Service Alert No: 001319

Title: 2017 MAZDA3 AND 2017 MAZDA6 MAINTENANCE MONITOR ENGINE OIL DATA
RESET

Mazda3**Mazda6 Type A Instrument Cluster****Mazda6 Type B Instrument Cluster****Available settings:**

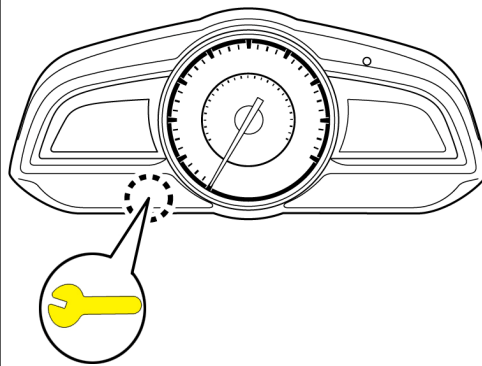
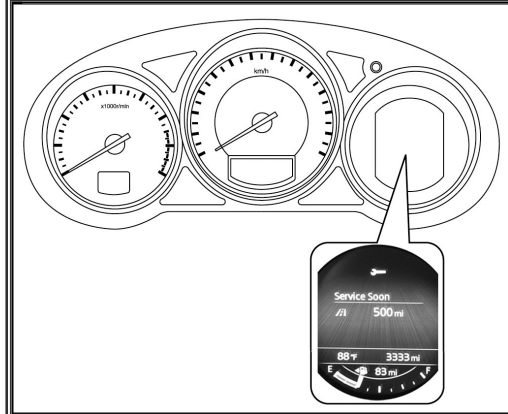
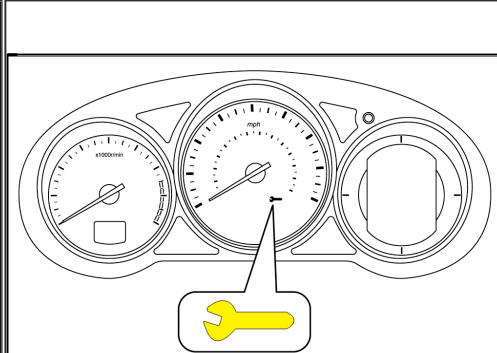
Engine Oil change reset procedure has changed for the 2017 Mazda3 and 2017 Mazda6. It is important to use this new procedure at every oil change to avoid a unnecessary customer return.

If oil data reset is not performed, a maintenance message will be displayed in the instrument cluster after the customer leaves the dealer.
